DEPN-25-0056 (Colorado Springs Temple); APPL-25-0008

2396 Veneto Way

In the Matter of the Appeal of the Planning)
Commission's Denial and Modification of)
the Administrative Approval of Project No.) Case No: APPL-25-0010
DEPN-25-0056 (Colorado Springs Temple))
in APPL-25-0008)

NOTICE OF ADMINISTRATIVE APPEAL TO CITY COUNCIL

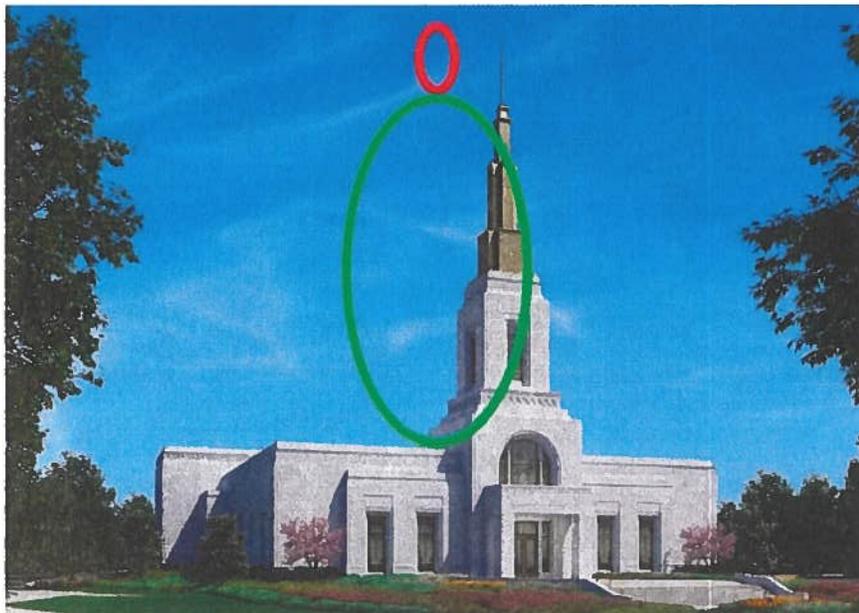
The Commission’s condition prohibiting illumination on only the uppermost 17 feet does not satisfy the UDC’s mandate that features exceeding district height limits be “designed or screened to minimize visibility” from residential zones. Even without illumination, the spire remains visually dominant. The record contains no evidence of any materials, massing, screening, or design strategies that could meaningfully reduce visibility of a structure that exceeds the MX-N height limit by nearly 100 feet.

Moreover, illumination of the remainder of the spire—still well over 120 feet—exacerbates its visual prominence. Continuous lighting increases contrast, expands the radius of nighttime visibility, and heightens the spire’s visual dominance over nearby neighborhoods. No findings or analysis support any conclusion that visibility has been minimized. To the contrary, the Planning Commission’s own modification acknowledges that illumination heightens visibility, yet it allowed illumination of the vast majority of the spire.

The graphic below demonstrates that the Planning Commission’s modification does not bring the Project into compliance with the UDC’s mandatory standard, and that the vast bulk of the spire remains entirely unmitigated:

- A. Reverse the Planning Commission’s action;
- B. Remand with directives requiring full compliance with UDC § 7.4.203(B)(2), including enforceable conditions governing structure height, massing, material reflectivity, lighting, and any design modifications necessary to meaningfully minimize visibility; and
- C. Vacate approval of any illumination of the spire as inconsistent with the UDC.

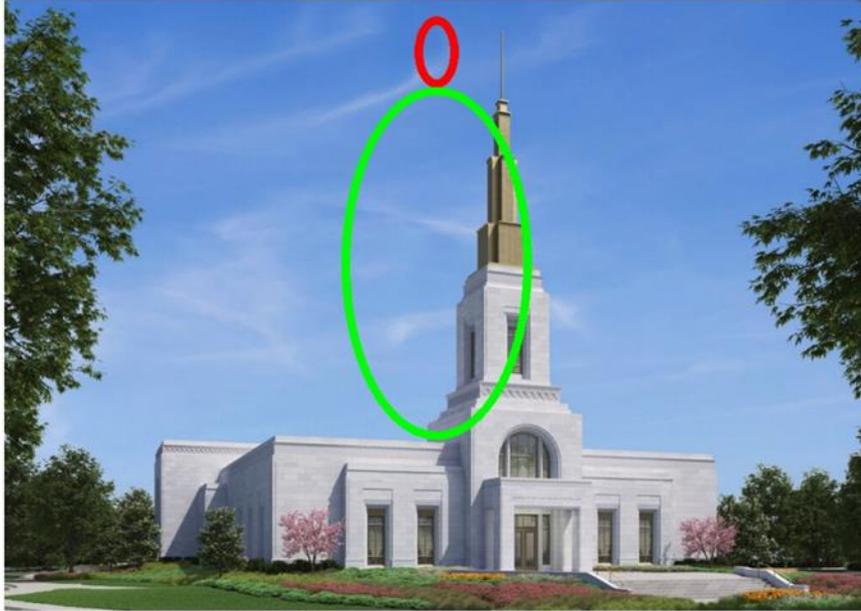
Nothing in the Commission’s partial prohibition on illuminating the top of the spire cures this fundamental incompatibility with § 7.4.203(B)(2). Even without illumination, the spire remains visually dominant. The record contains no evidence of any materials, massing, screening, or design strategies that could meaningfully reduce the visibility of a structure that exceeds the MX-N height limit by nearly 100 feet. At this scale, visibility is not a design choice—it is an inevitability.

The Commission’s condition prohibiting illumination of only the top portion of the spire does not satisfy the UDC’s mandate that features exceeding district height limits be designed or screened to minimize visibility from residential zones. Allowing illumination of the remainder of the spire—still well over 120 feet tall—exacerbates the problem.

Continuous lighting increases contrast against the night sky, expands the radius of nighttime visibility, and heightens the spire’s visual dominance over nearby neighborhoods. No findings or analysis support any conclusion that visibility has been minimized. To the contrary, the Commission’s modification implicitly acknowledges that illumination heightens visibility, yet it allowed illumination of the vast majority of the spire.

The graphic below illustrates that the Planning Commission’s modification does not bring the Project into compliance with the UDC’s mandatory standard and that the vast majority of the spire remains entirely unmitigated:

- A. Reverse the Planning Commission’s action to the extent it failed to provide full relief or, at a minimum, remand with instructions requiring specific findings supported by competent evidence;
- B. Return the matter to the Planning Commission and/or the relevant planning official with directives requiring full compliance with the UDC including enforceable conditions governing structure height,
